Subject: Notification of a Class 1 Permit Modification to the Waste Isolation Pilot Plant  
Hazardous Waste Facility Permit Number: NM4890139088-TSDF

**Class 1 Permit Modification Notification**

**Update Panel Closure Information**

**Waste Isolation Pilot Plant  
Carlsbad, New Mexico**

**Figure H1-1**  
**Spatial View of WIPP Surface and Underground Facilities**

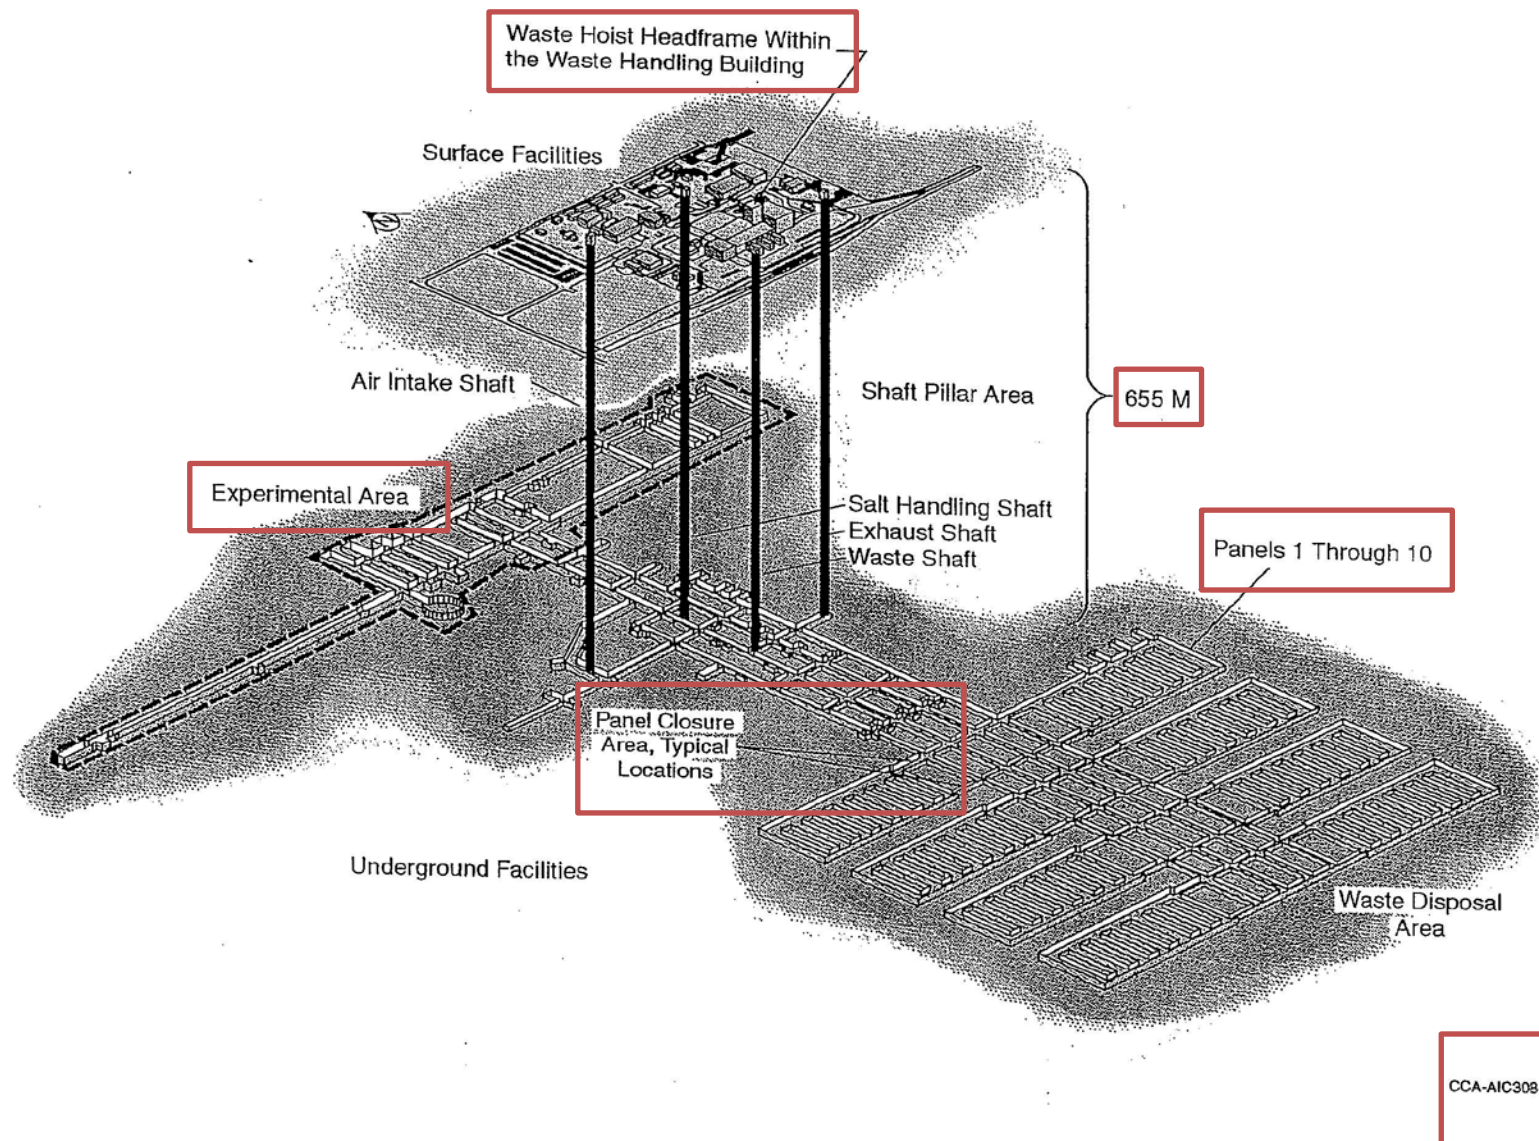
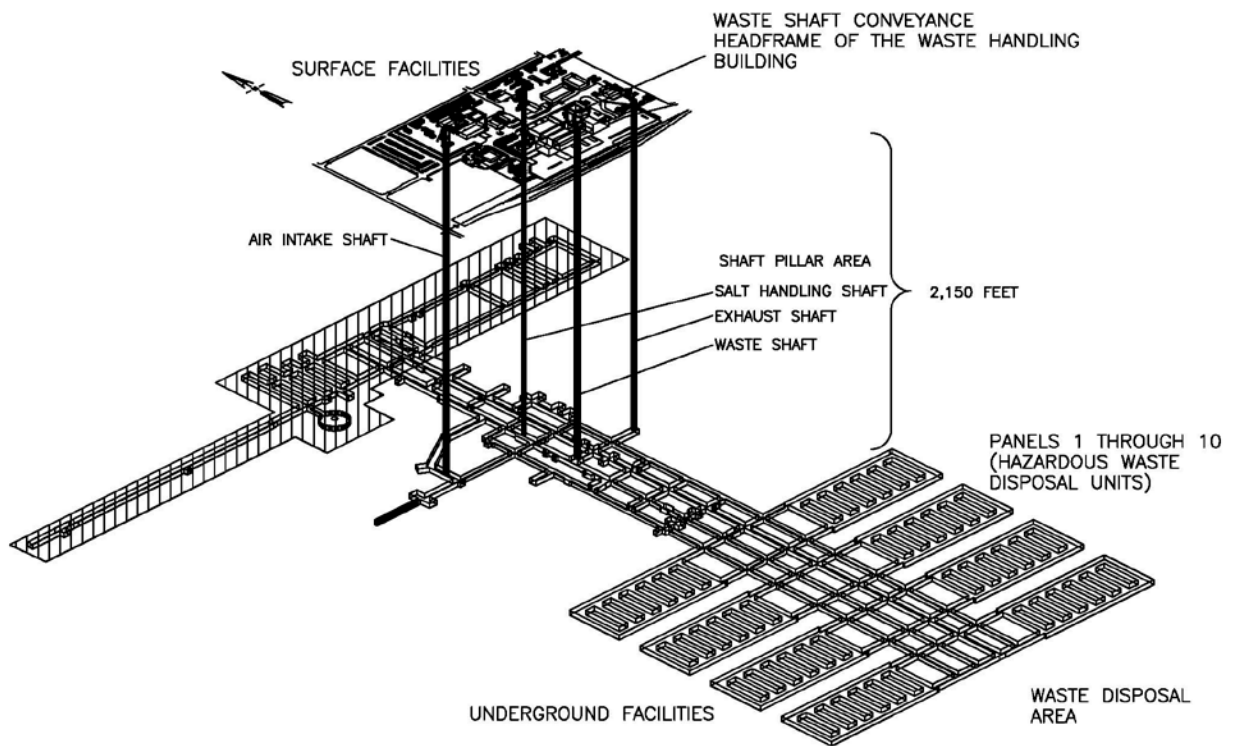
- Permit Attachment H1, Figure H1-1, *Spatial View of WIPP Surface and Underground Facilities*
  - Make figure consistent with the other figures in the Permit that depict the spatial view of the WIPP facility.

- Removed panel closure label.
- Changed “655 M” to “2,150 FEET.”
- Added “(HAZARDOUS WASTE DISPOSAL UNITS)” To “PANELS 1 THROUGH 10” label.
- Removed “Experimental Area” label.
- Changed “Waste Hoist Headframe Within the Waste Handling Building” label to “WASTE SHAFT CONVEYANCE HEADFRAME OF THE WASTE HANDLING BUILDING.”
- Capitalized the figure labels.
- Removed number in the lower right-hand corner of the figure.
